MCPB
Item No. 7
Date: 10.28.2021

2710 Washington Avenue, Administrative Subdivision 620190130

Administrative Subdivision Plan No. 620190130

2710 WASHINGTON AVENUE
FIRE ACCESS PLAN
ADMINISTRATIVE SUBDIVISION
FILE NO: 620190130

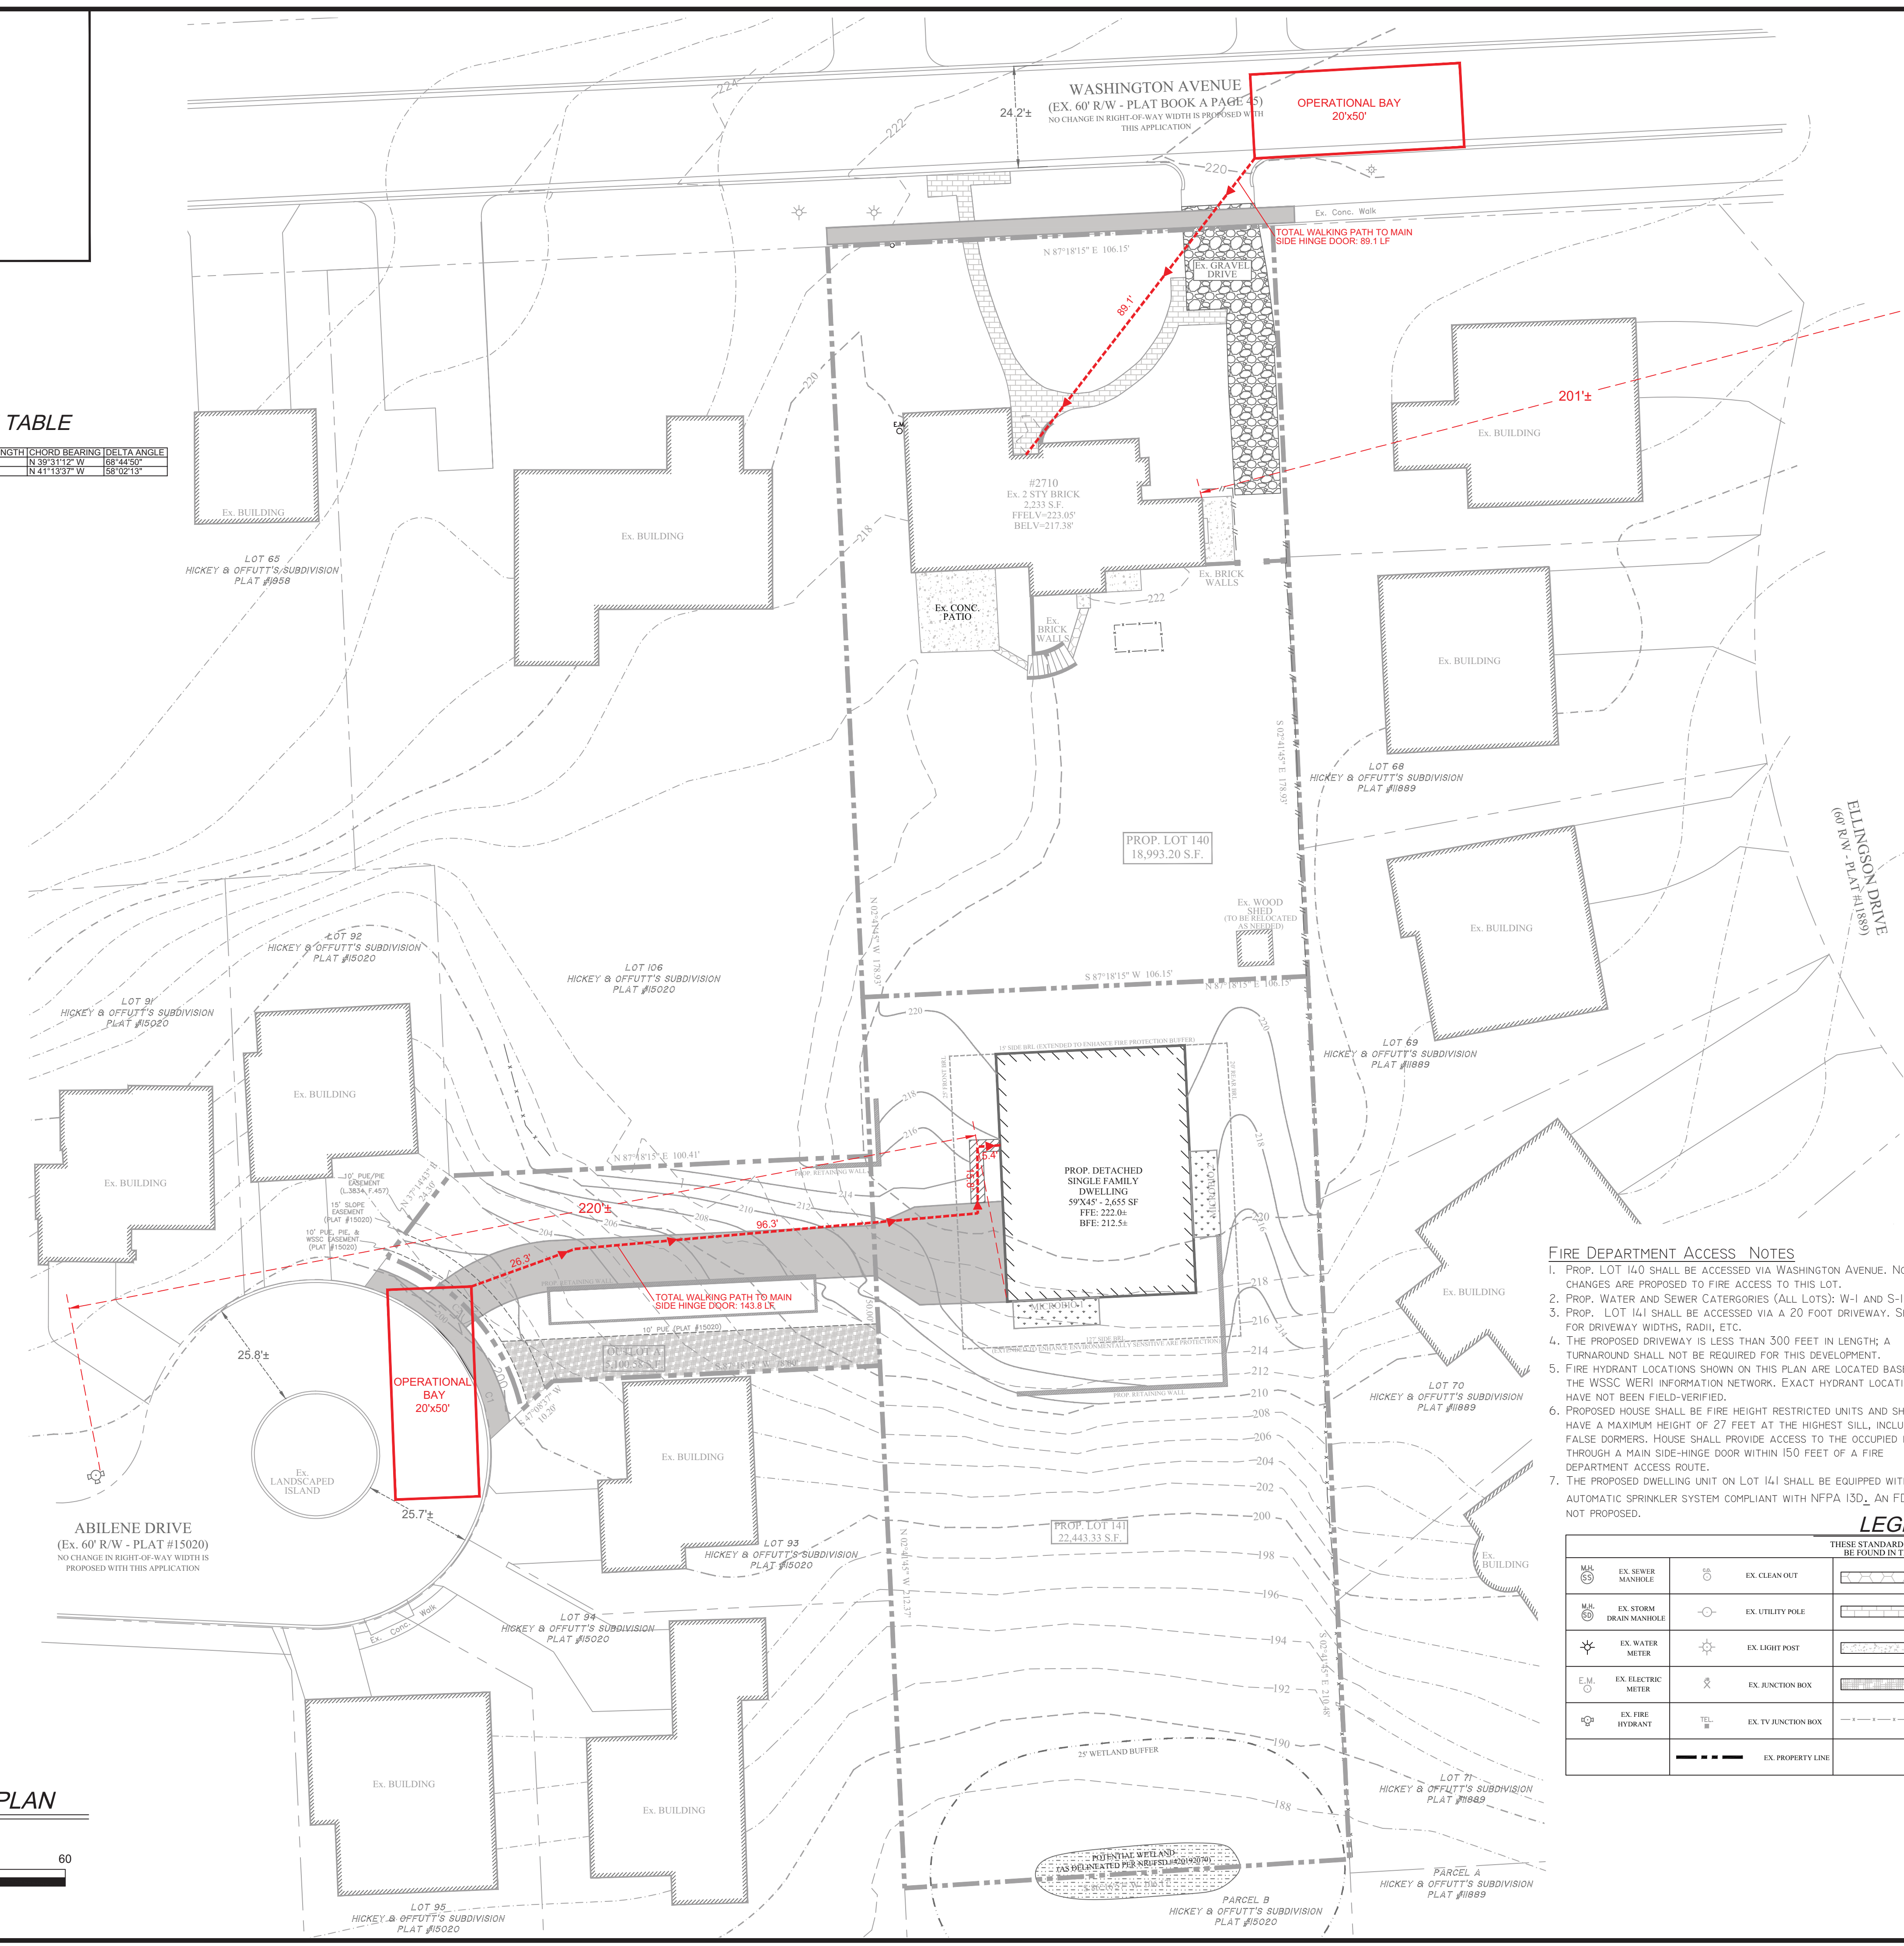
FIRE CODE ENFORCEMENT

Fire Department Access Review

Review based only upon information contained on this plan. Does not cover unsatisfactory layout resulting from omissions, errors or failure to clearly indicate conditions on this plan. Correction of such unsatisfactory layout to afford required access will be required if found upon inspection after installation

*** Developing one lot in existing subdivision with existing method of access already in place per original community planning ***
